Micro-sited Smaller Turbine Layout Alternative

Overview

Figure 8: SH14-1,4,-2,-3 are representative of Layouts 1-4. SH14-5 was relocated 130 ft N away from southern shoulder in response to Estep's recommendation and is the Micro-sited Smaller Turbine Layout (Layout 5).

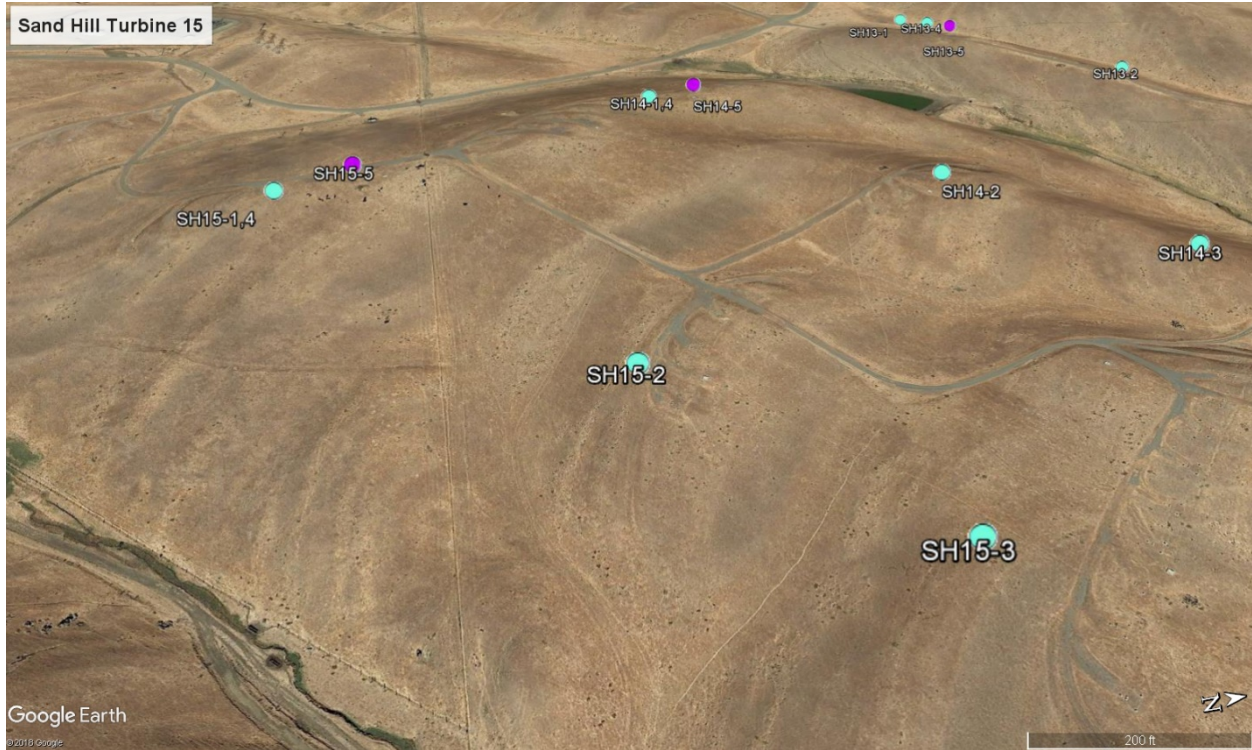
SH14-1,4	Yes, modified	GE 3.8	GE 2.8	7.5	3	Use site 14-2.	No. Cannot use site 14-2 in Layout 4 due to wake effect.	High	Move 130 feet north along ridge.	Yes. Moved 130 feet north, farther from the shoulder on the south. Although move likely to negatively impact wake, prioritized this move due to high risk designation.	Yes - turbine moved, blade height above ground increased, and RSA and MWs reduced.
SH14-2	No	GE 3.8	-	6.5	2	None.	N/A. Cannot use this site in Layout 4 due to wake effect.	Low-Mod	Use this site.	Unable to use this site due to wake effect.	Yes - site removed.
SH14-3	No	GE 3.8	-	7	3	Use site 14-2.	N/A	Mod	None.	Not using this site.	Yes - site removed.
SH15-1,4	Yes, modified	GE 3.8	GE 2.8	6	2 (3)	Shift north 25 m.	No. Turbine could not be moved due to wake.	High	Move 140 feet northwest to top of ridge.	Yes. Moved 140 feet northwest to top of ridge. Although move likely to negatively impact wake, prioritized this move due to high risk designation.	Yes - turbine moved, blade height above ground increased, and RSA and MWs reduced.

Figure 12: SH20-1,4,-2,-3 are representative of Layouts 1-4. SH20-5 was relocated 80 ft N/NE to highest point on the ridge in response to Estep's micro-siting recommendation and is the Micro-sited Smaller Turbine Layout (Layout 5).

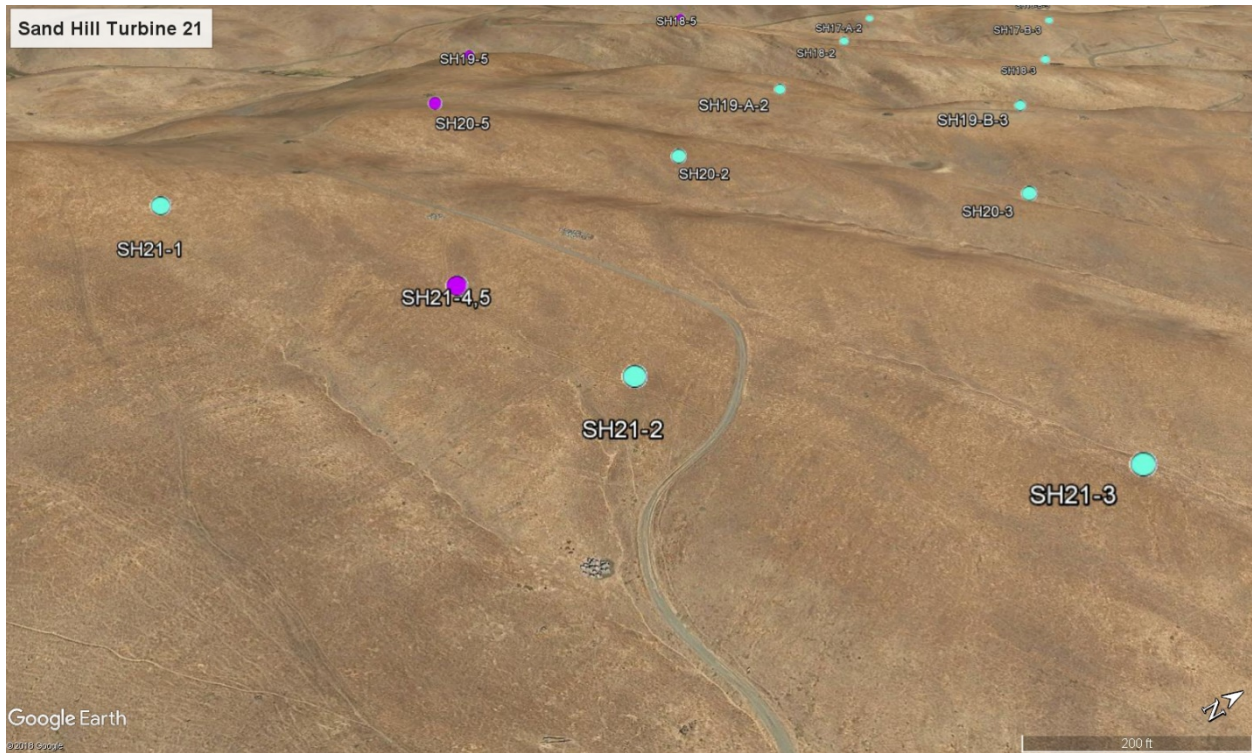
- **Turbine 20.** In Layouts 2 and 3, Turbine 20 presented what Estep (2019) predicted would be a moderate collision risk, owing in part to the expected effects of grading for road access to those sites. (Estep (2019), Appendix A-2). Smallwood and Neher (2018) recommended siting Turbine 20 on the crest of a hill near the location proposed in Layout 1. (Smallwood and Neher (2018) at 77). However, because this would have resulted in two or more turbines being placed so closely together that wake interference would render them commercially infeasible, Sand Hill was unable to so relocate Turbine 20 in Layout 4. (Turbine Spreadsheet). Estep (2019) concluded that the Layout 1 site would pose a low to moderate risk, and did not anticipate special risks due to grading. (Estep (2019), Appendix A-2). Estep further concluded that this risk could be further mitigated by moving Turbine 20 approximately 80 feet. (*Id.*). In the Micro-sited Smaller Turbine Layout alternative, Sand Hill located Turbine 20 in accordance with the Estep (2019) recommendation. (Turbine Spreadsheet). In addition, it reduced the size of Turbine 20 by over 26%, from 3.8 MW to 2.8 MW. (*Id.*) This cut Turbine 20’s rotor-swept area by approximately 14%, from 14,741 m² to 12,668 m², and raised its blades approximately 92% higher off the ground (from 13m to 25 m), thereby further lessening risk to birds and bats.

Figure 17: SH29-1,2,3 is representative of Layouts 1-3. SH29-4 was relocated 60 m E in response to Smallwood's recommendation. SH29-5 was relocated an additional 165 ft SE from the edge of the swale following a site visit and is the Micro-sited Smaller Turbine Layout (Layout 5).

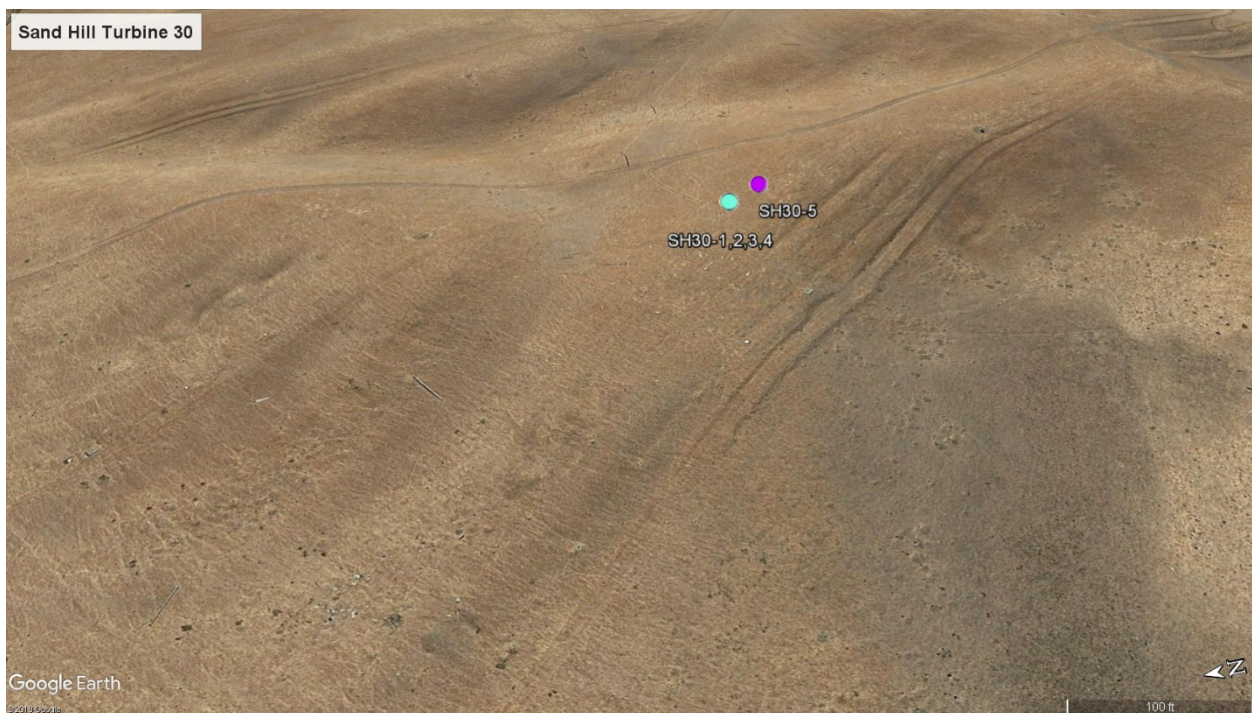
- **Turbine 29.** Both Smallwood and Neher (2018) and Estep (2019) concluded that Turbine 29 as proposed in Layouts 1-3 would pose a considerable collision risk to raptors, with Estep designating it a relatively high-risk site. (Smallwood and Neher (2018) at 74-75; Estep (2019), Appendix A-3). Smallwood and Neher (2018) recommended moving the turbine east toward

higher ground. (Smallwood and Neher (2018) at 77). Sand Hill did so in Layout 4, and Estep (2019) confirmed that the new site would reduce risk to moderate-to-high levels. (Estep (2019), Appendix A-3). Estep noted, however, that “placement of a turbine pad at this location could create a notch along the top of the slope above the swale and potentially result in additional risk,” and recommended further moving Turbine 29-4. (*Id.*). Although setback requirements prevented Sand Hill from accommodating this recommendation, Sand Hill proposed another alternative location for Turbine 29 following additional site visits; Estep confirmed that this location—used in the Micro-sited Smaller Turbine Layout alternative—would reduce expected collision risks to a low-to-moderate level. (*Id.*). In addition, Turbine 29 is reduced from 3.8 MW (rotor-swept area of 14,741 m² with blades 13 m from the ground) to 2.3 MW (rotor swept area of 10,568m² with blades 22m from the ground), which is expected to further reduce collision risks for birds and bats by reducing rotor-swept area by 28% and increasing blade height from the ground by 69%.
